ADDENDUM NO. 1 TO PROJECT NO. 45404

**CONSTRUCTION, HVAC, PLUMBING AND ELECTRICAL WORK
PROVIDE BATTALION HEADQUARTERS, BUILDING 75
CAMP SMITH TRAINING SITE
11 BEAR MOUNTAIN BRIDGE ROAD
CORTLANDT MANOR, NY 10567**

August 18, 2016

SHEET TITLE: MASONRY REPAIR DETAILS

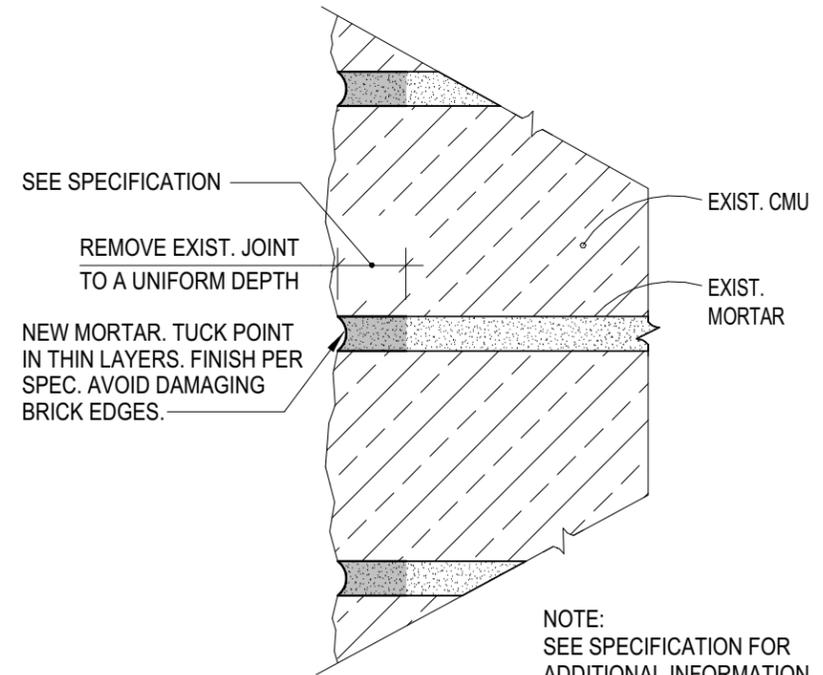
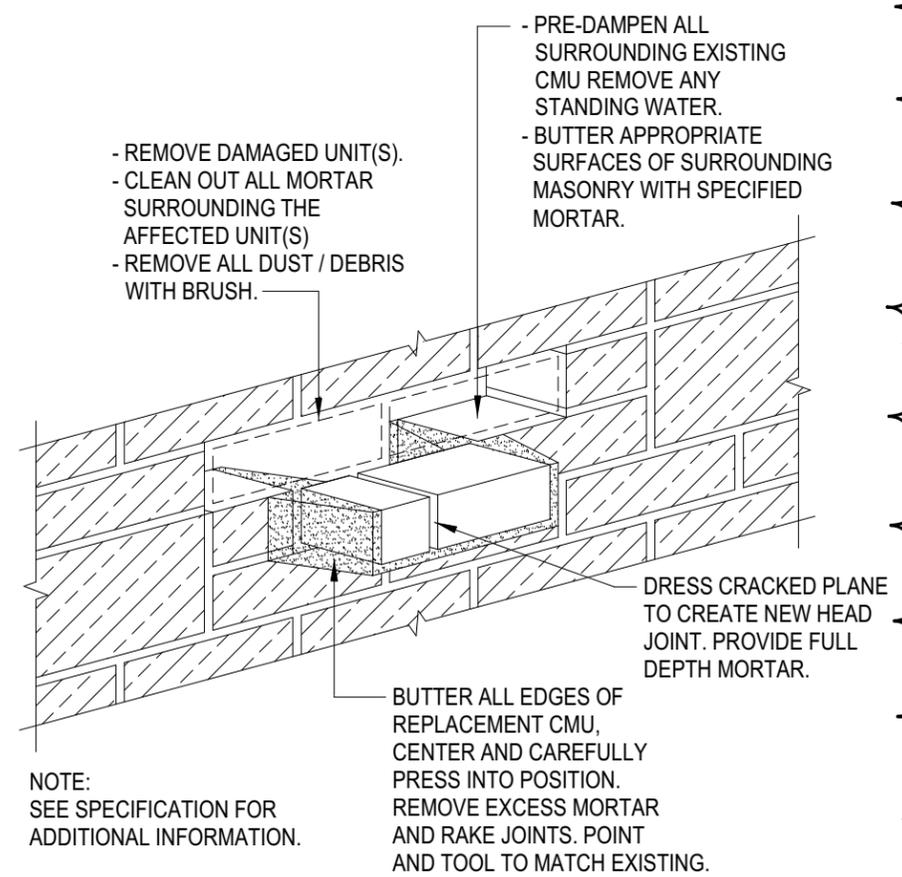
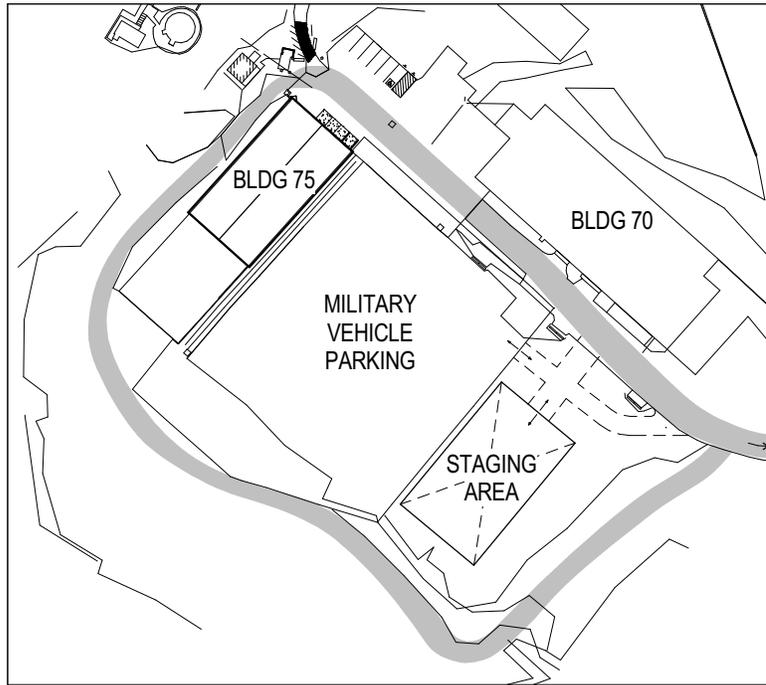
6. Drawing No. AD-101:
 - a. Key Note – Removals: Note R7; change to read, “Area of depressed asphalt pavement. Remove pavement and excavate 12 inches of material. Fill with engineered fill and compact to 95%. Cut edges of excavation at a 1 to 2 slope. Bring stone to finish surface of existing pavement. Existing sub base to be inspected by Director’s Representative. Proceed with engineered fill pending results.”
 - b. Key Note – Removals: Note R3; delete “VERIFY IN FIELD”.
 - c. Key Notes Masonry Repair: Note 01; change to read, “Area of masonry repair, see Details A1, A3 & B1/AD-101.” See JD-A1 Addendum Drawing dated 10 Aug 2016.
 - d. Add details A3/AD-101, CMU REPLACEMENT DETAIL; B1/AD-101, CMU CRACK REPAIR DETAIL; A1/AD-101, JOINT REPOINTING DETAIL”. See JD-A1 Addendum Drawing dated 10 Aug 2016.

D4

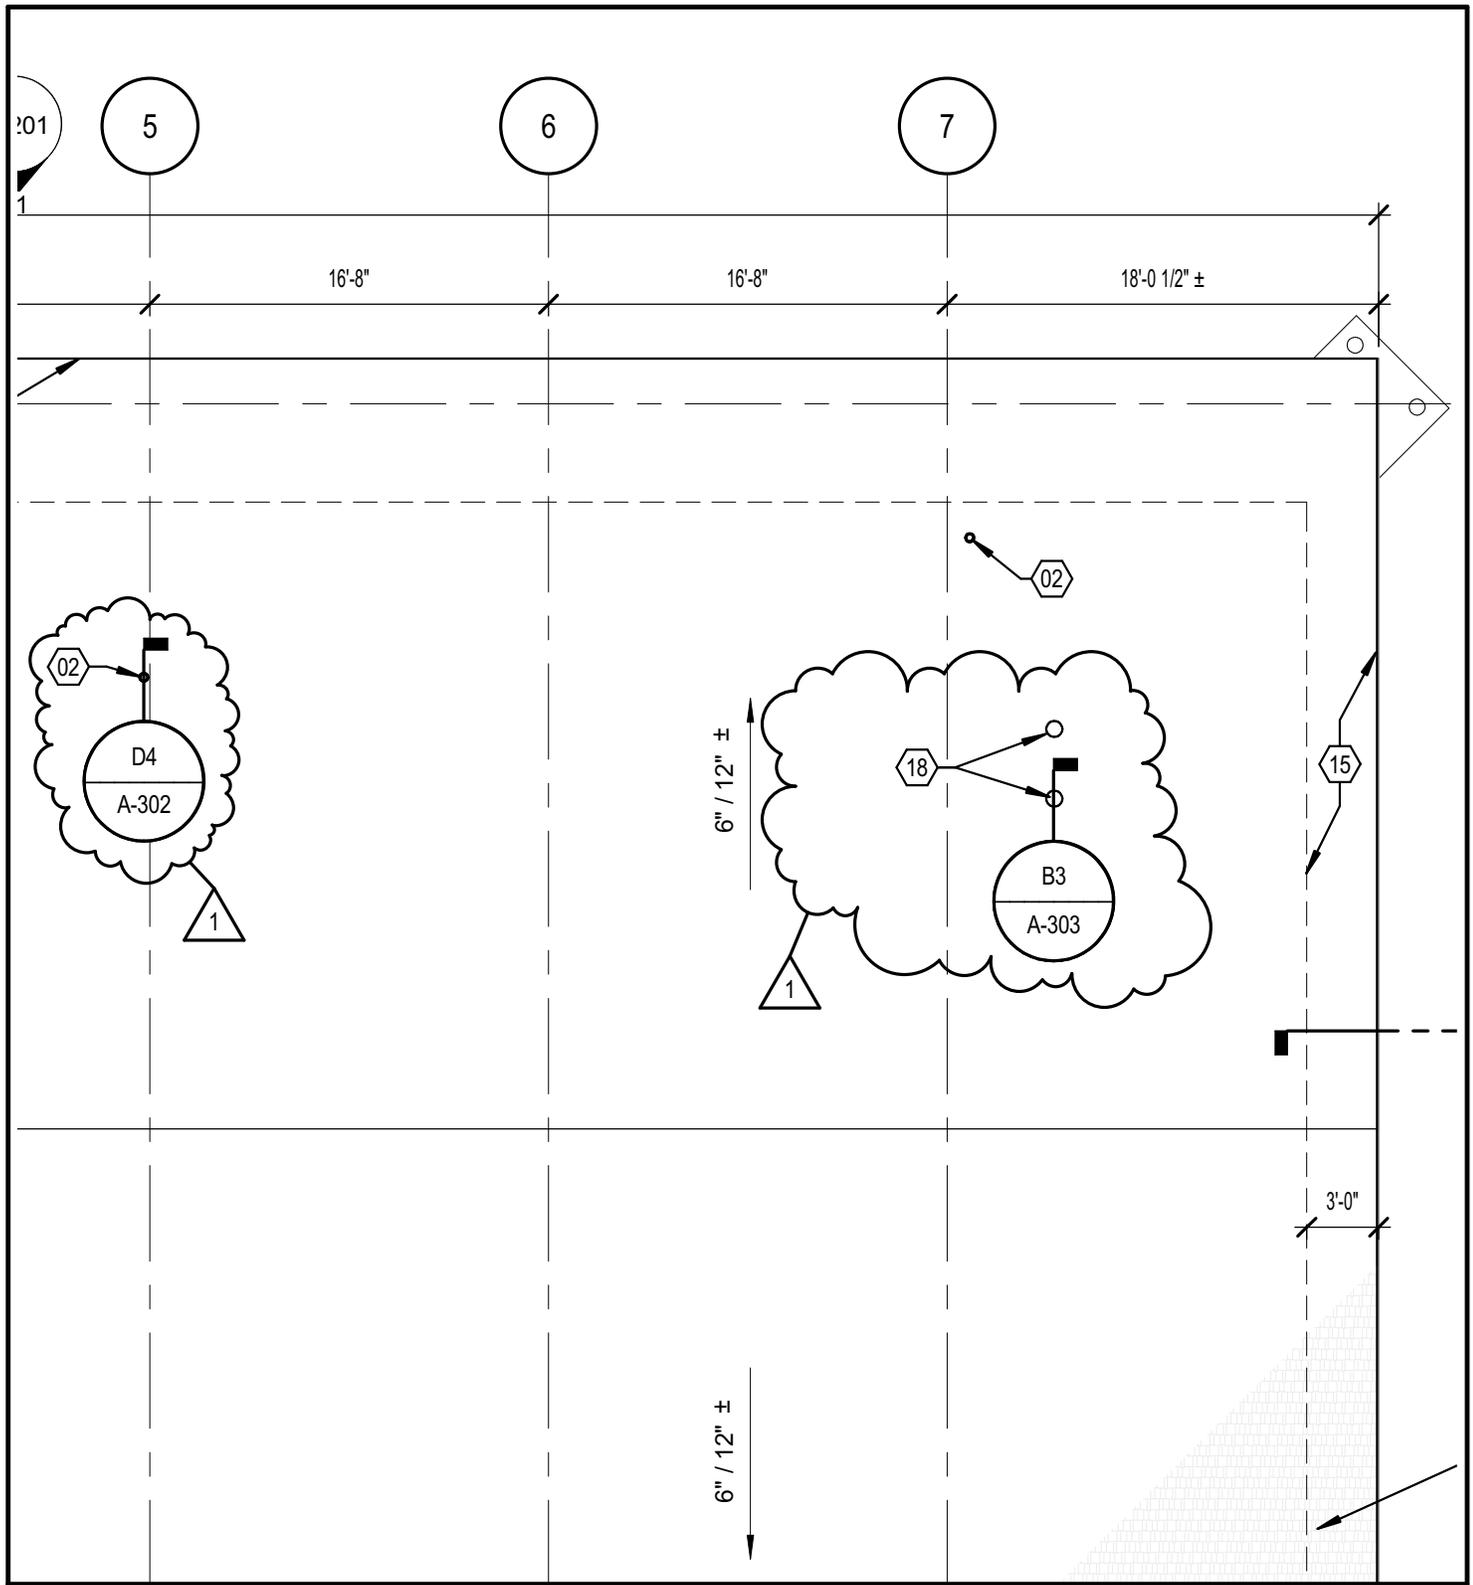
5. Drawing No. G-002:
 - a. General Notes; add the following text to Note Number 2, "Partial scope of this project includes removal and replacement of the roof deck, temporary stability of existing masonry walls and structural steel frame is the responsibility of the contractor. Temporary shoring of the existing masonry walls and structural steel members must be designed and coordinated by a NYS Licensed Professional Engineer. Required temporary shoring must be in place until the new roof system is fully installed and fastened to the existing structure per the contract documents."
 - b. D1/G-002 Code Analysis, #18, a.; Revised to state, "Required = 6,053 x 0.08 = 484 sf, Actual = 677 SF".
 - c. Add detail D4/G-002, STAGING AREA. See JD-A2 Addendum Drawing dated 10 Aug 2016

SHEET TITLE:
 A2/A-301 WALL SECTION- SOUTH WALL

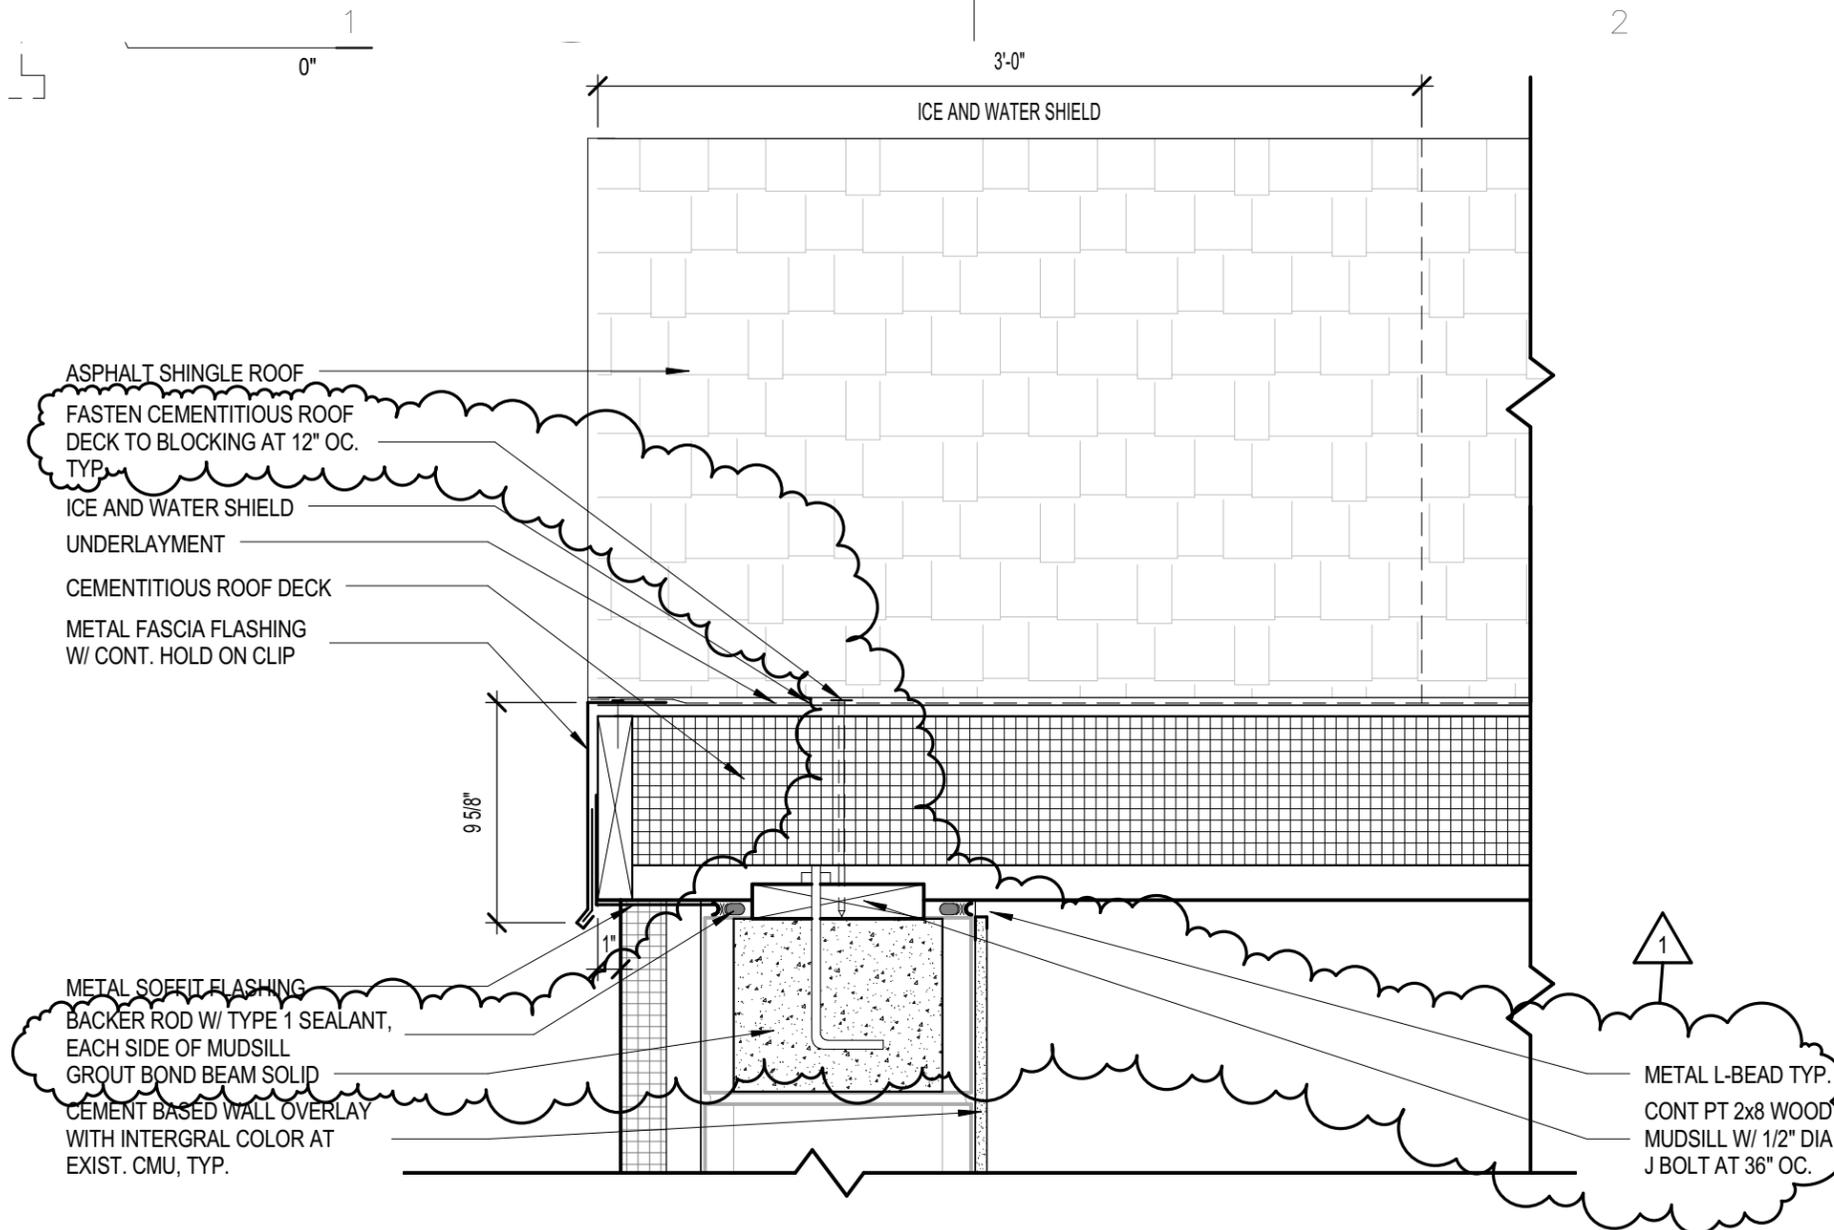
- a. Detail A4; Revise detail with JD-A9 and JD-A10 Addendum Drawing dated 10 Aug 2016.
- b. Detail D4; Revise detail with JD-A11 Addendum Drawing dated 10 Aug 2016.
- c. Detail C5; Revise detail with JD-A12 Addendum Drawing dated 10 Aug 2016.
- d. Detail A1; Revise detail with JD-A7 Addendum Drawing dated 10 Aug 2016.
- e. Detail A2; Revise detail with JD-A8 Addendum Drawing dated 10 Aug 2016.

SHEET TITLE:
A4/A-302 & A5/A-302 REVISED
SECTION - AIR INTAKE & TYP.
LOUVER DETAIL

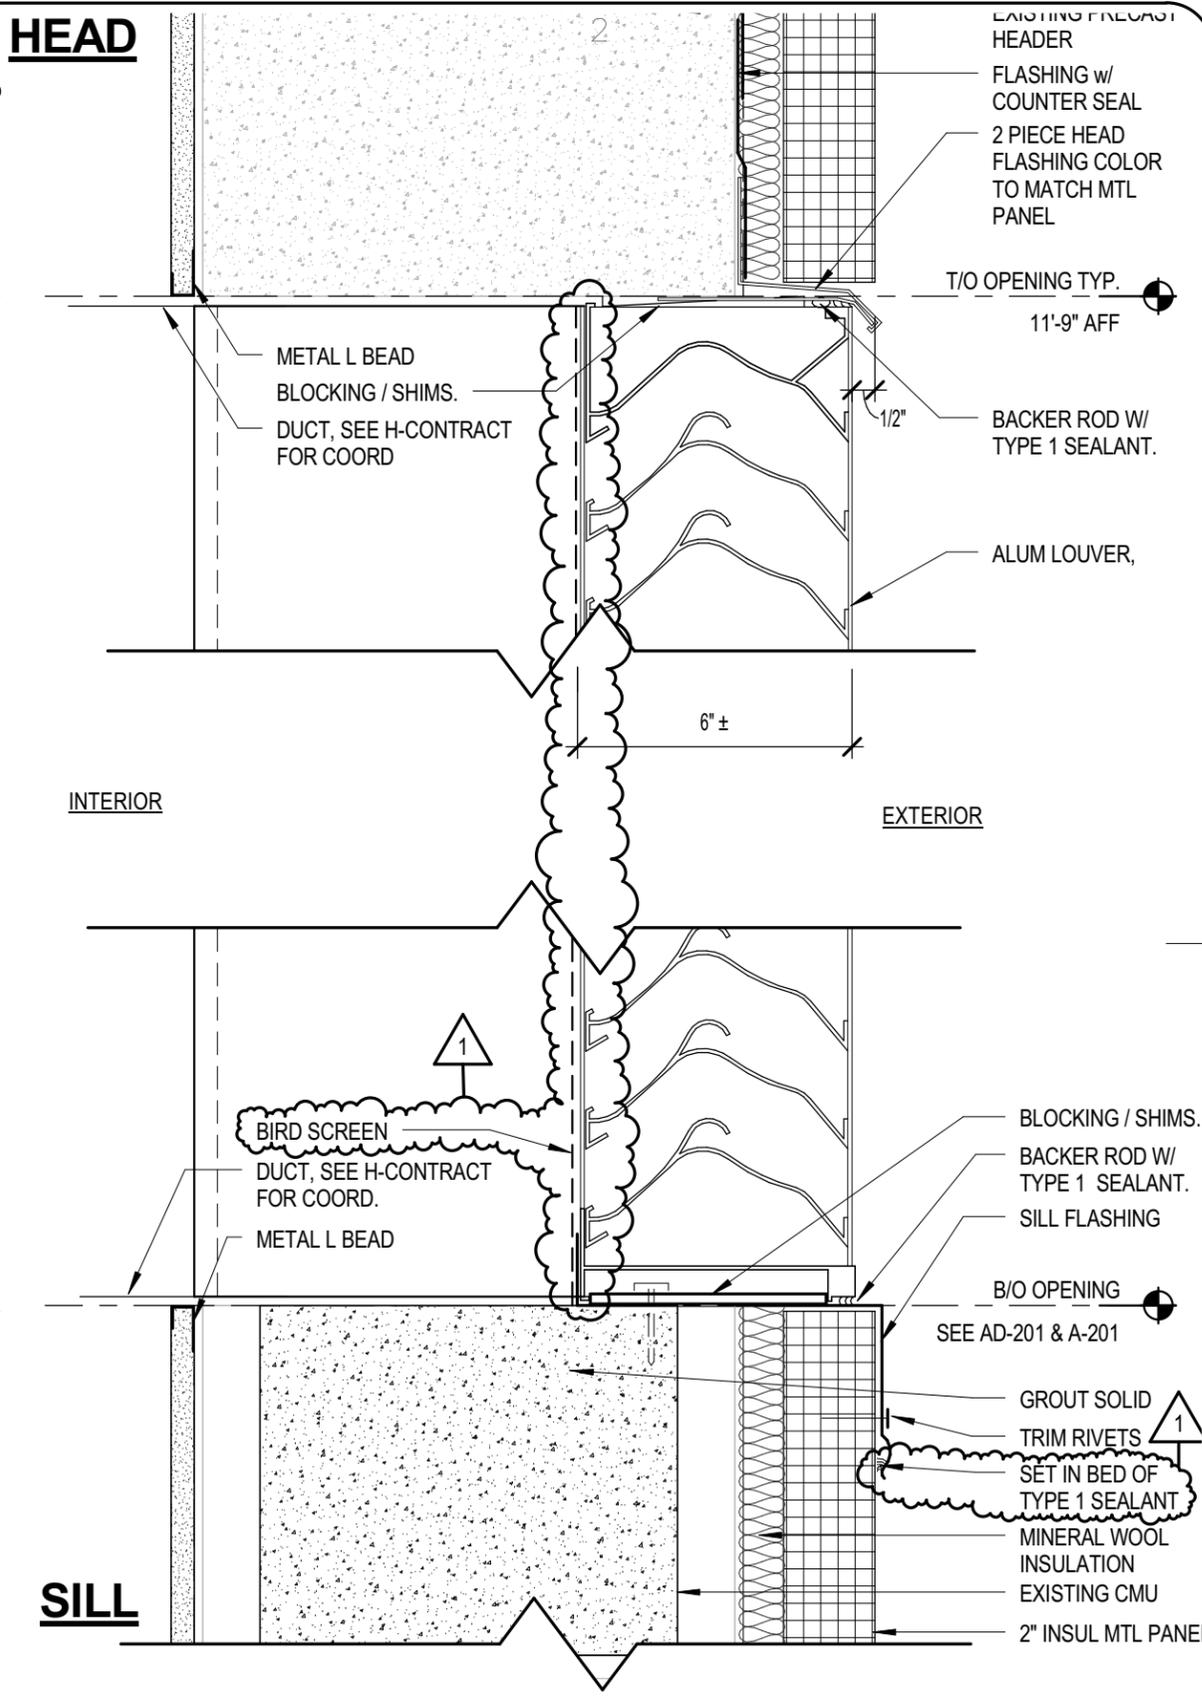
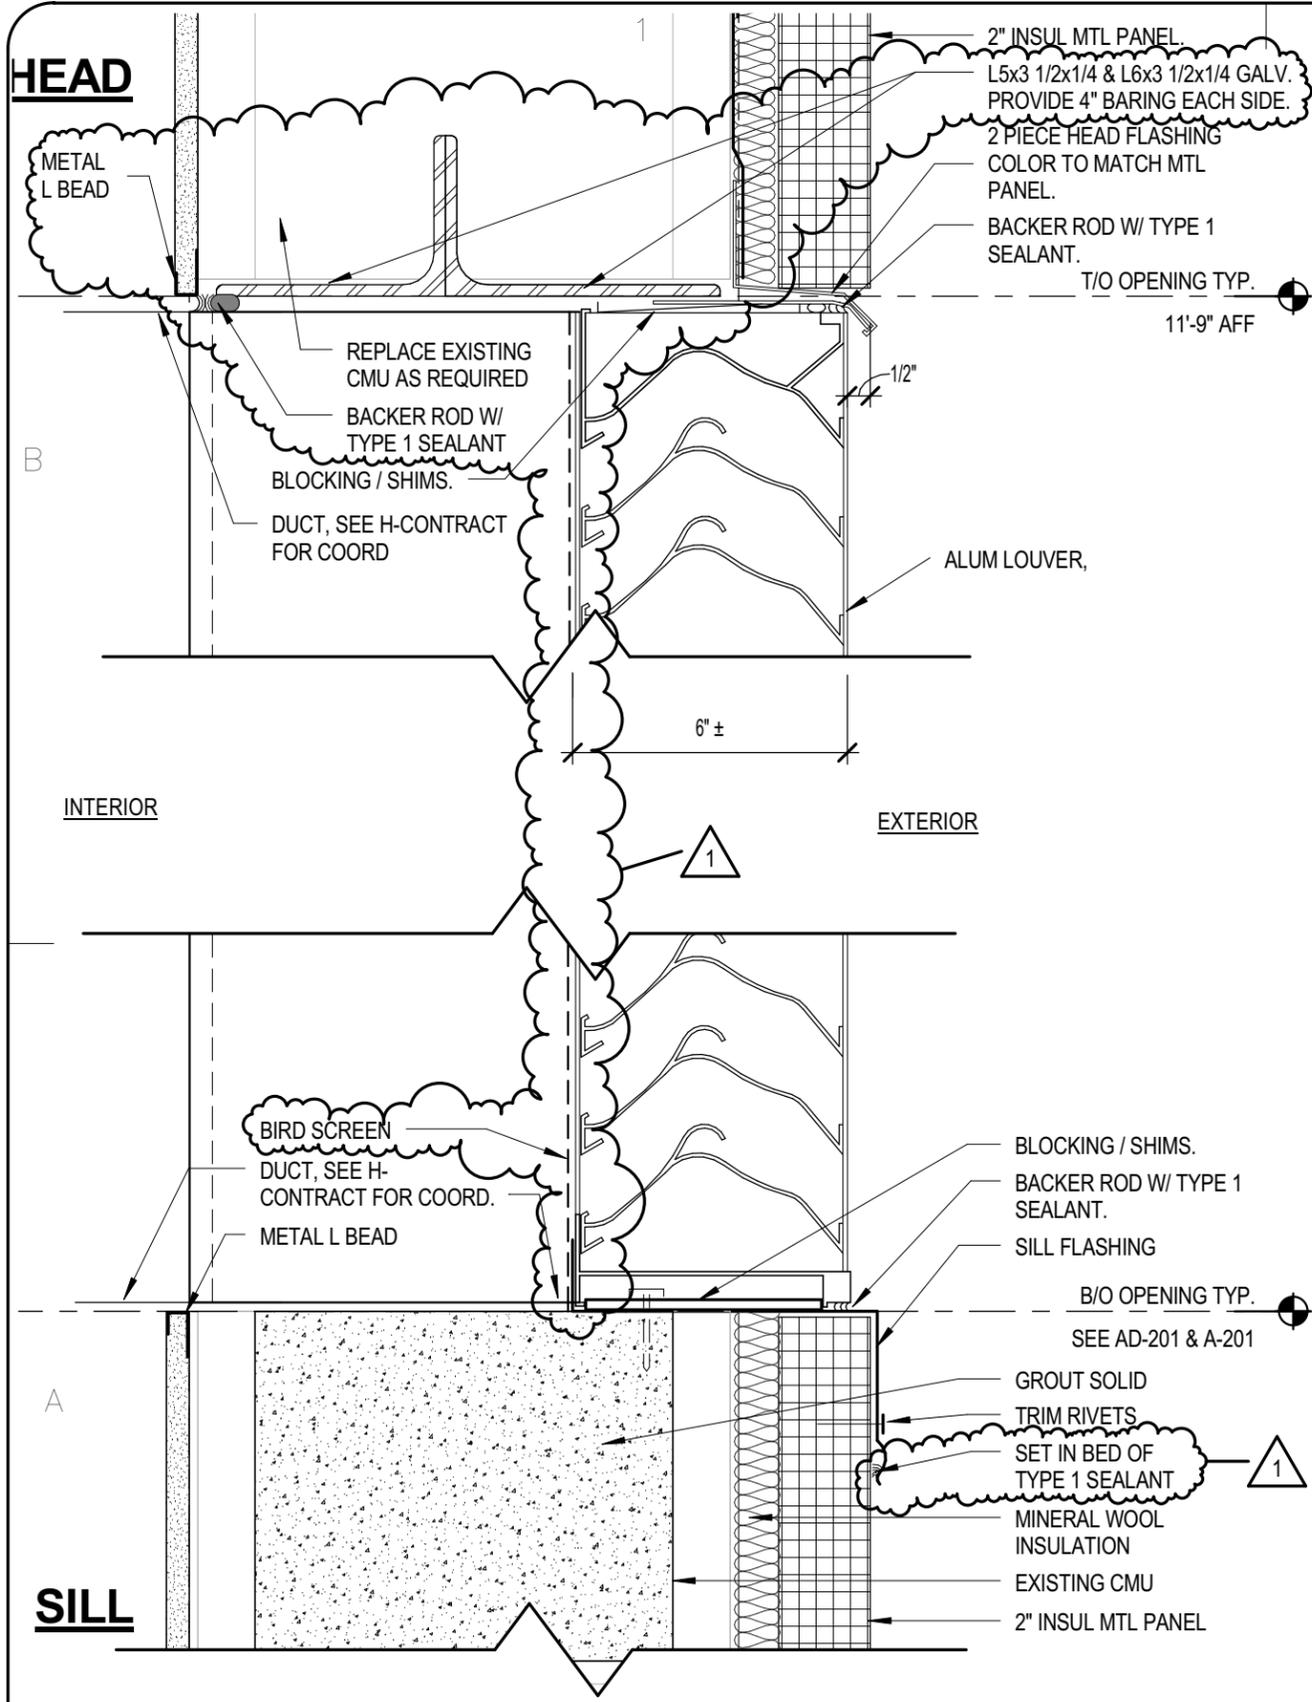
- a. Detail A1; Revise detail with JD-A15 Addendum Drawing dated 10 Aug 2016.
- b. Detail A3; Revise detail with JD-A14 Addendum Drawing dated 10 Aug 2016.
- c. Details A4 and A5; Revise details with JD-A13 Addendum Drawing dated 10 Aug 2016
